**Infrastructure and Transportation**  
Highway Planning and Design Branch  
Environmental Services Section  
1420-215 Garry Street, Winnipeg, MB R3C 3P3  
T 204-619-4359 F 204-945-0593  
www.manitoba.ca

April 10, 2015

**SUBJECT: Notice of Alteration - Environment Act Licence No. 3131  
St. Adolphe Ring Dike Expansion**

Attachment 1  
Plan View Drawing

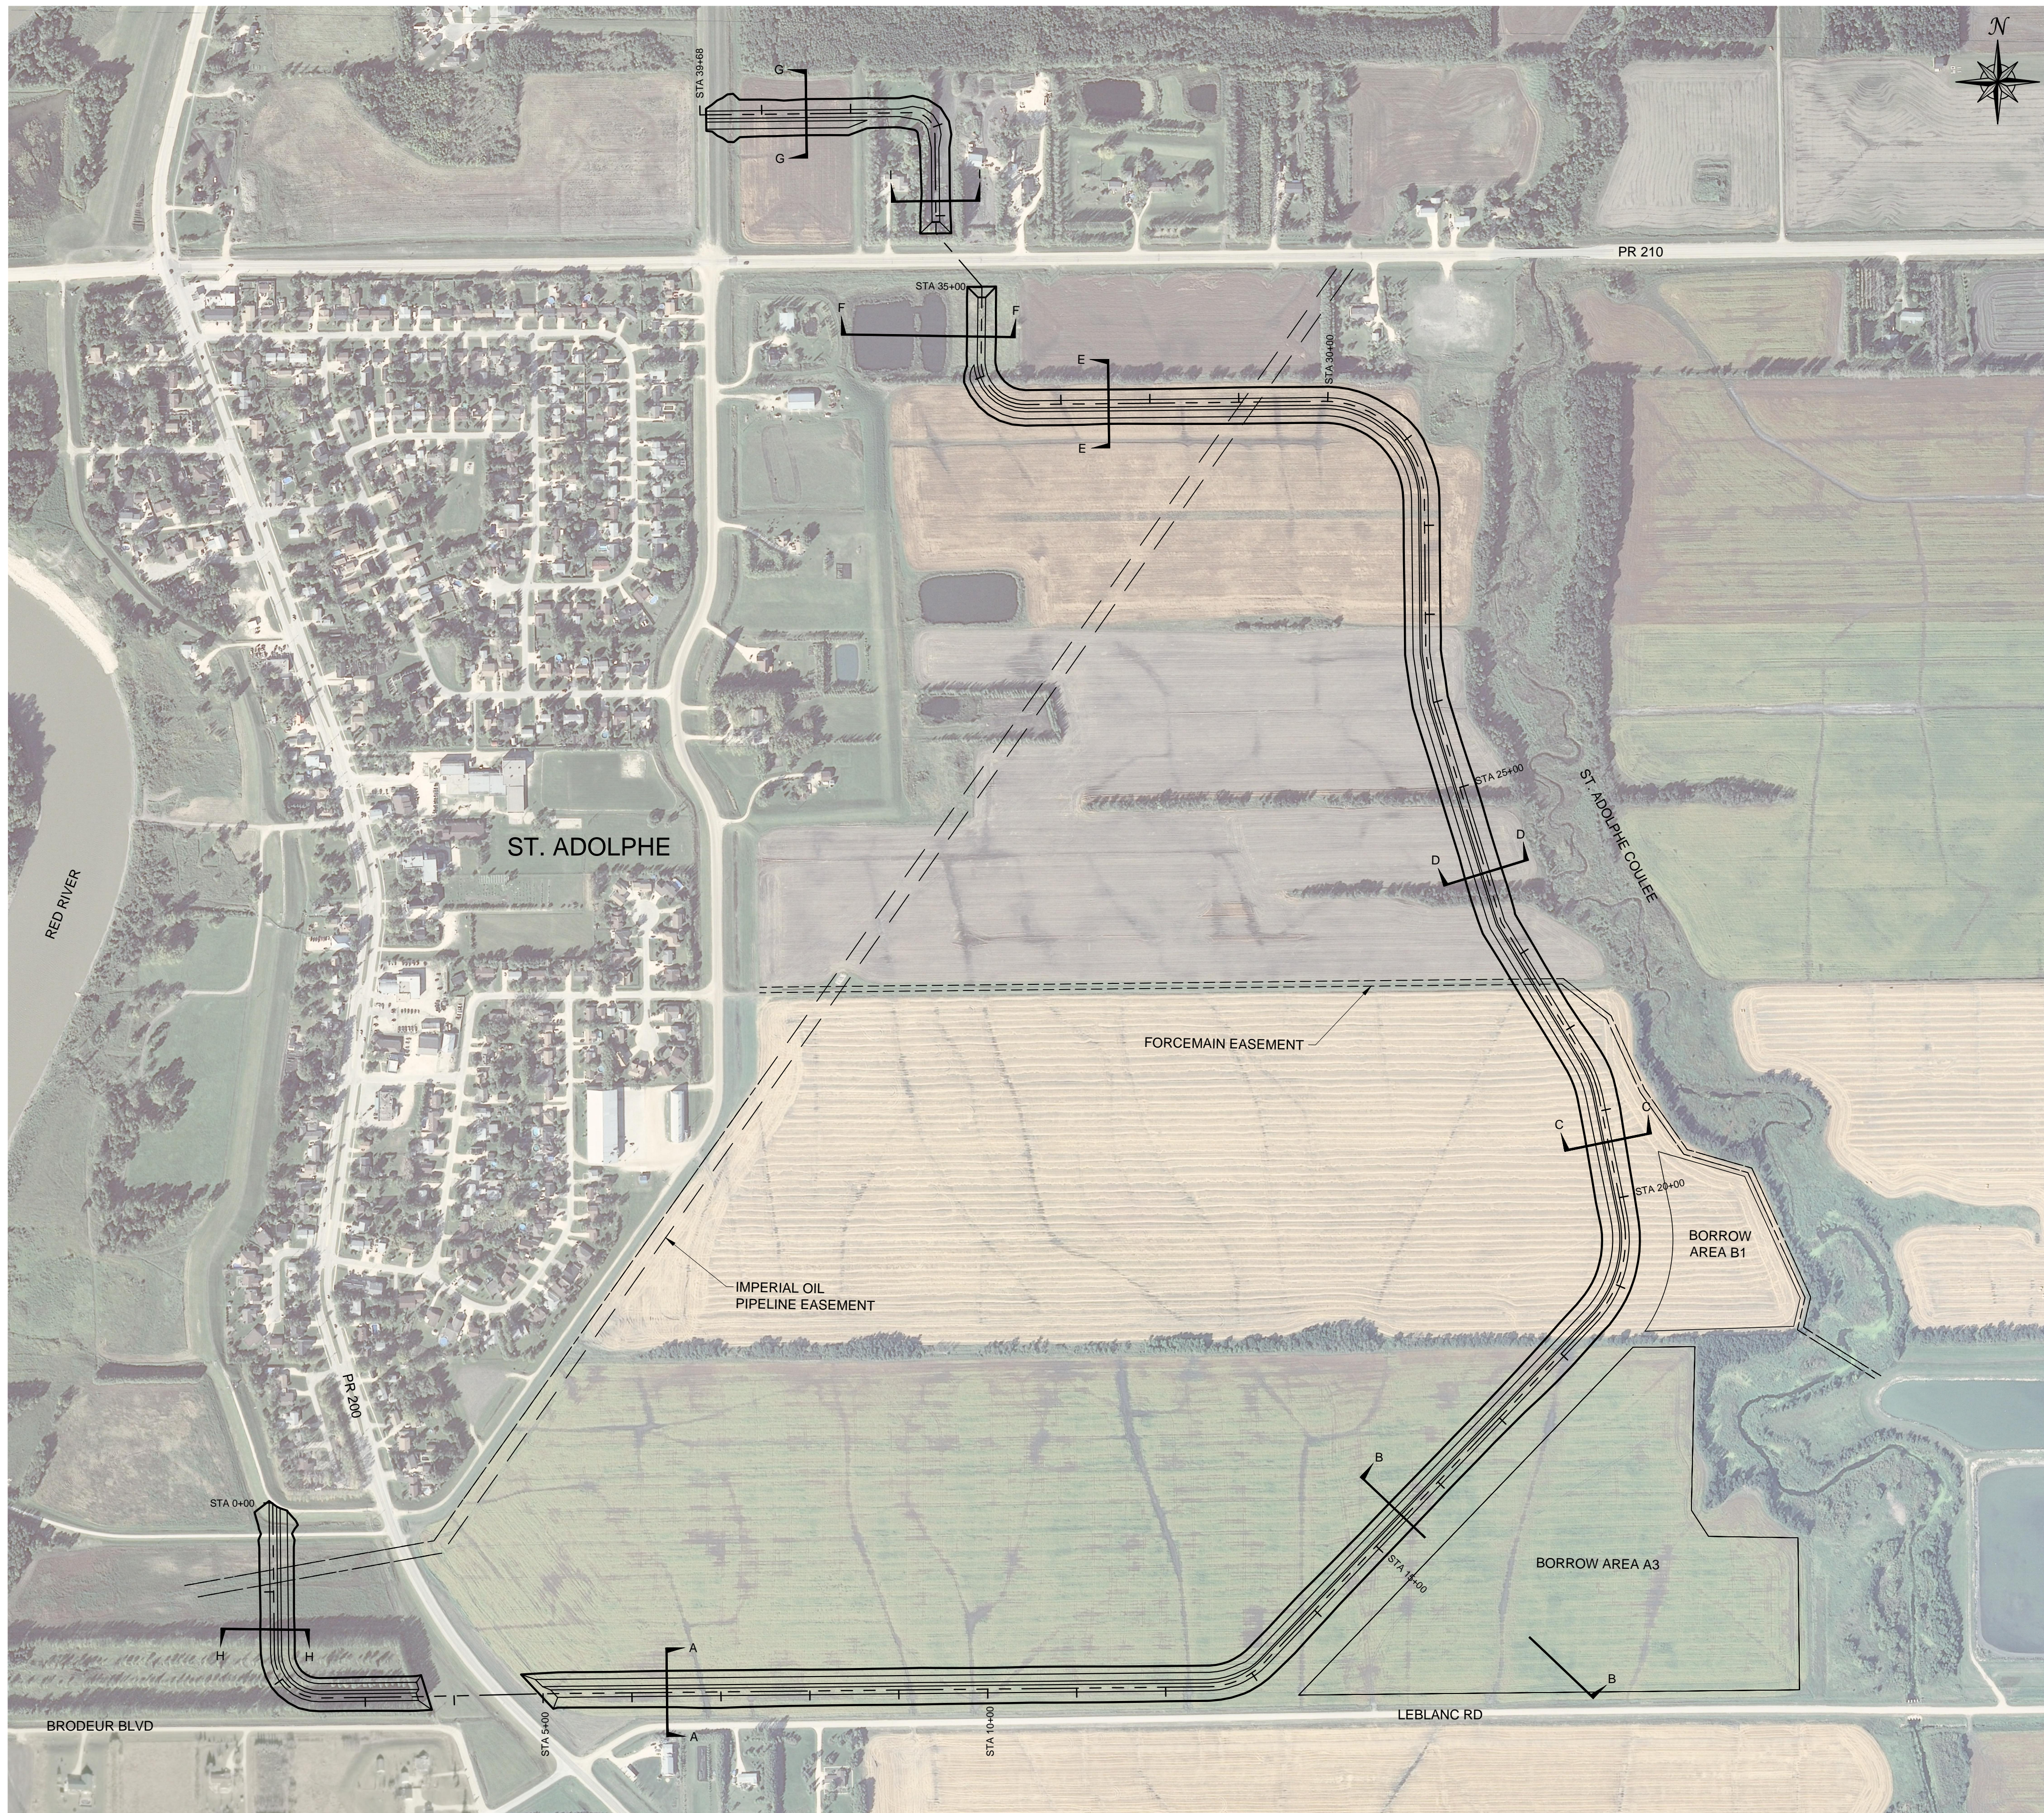
The dike alignment in the southeast corner of the project has been changed to allow for two borrow areas (A-3 and B-1) to be dug outside of the flood protected area. The location of the flood control structure will be moved to the southeast corner of the new dike to drain urban storm water from within the diked area into borrow area A-3 (see Attachment 1).

Borrow areas will now be located outside of the flood protected area, between the proposed dike and the St. Adolph Coulee. Borrow site B-1 will be located within 20 m of the Coulee. Borrow site A-3 will be located within approximately 80 m of the Coulee. Neither borrow area will encroach on the riparian area of the coulee.
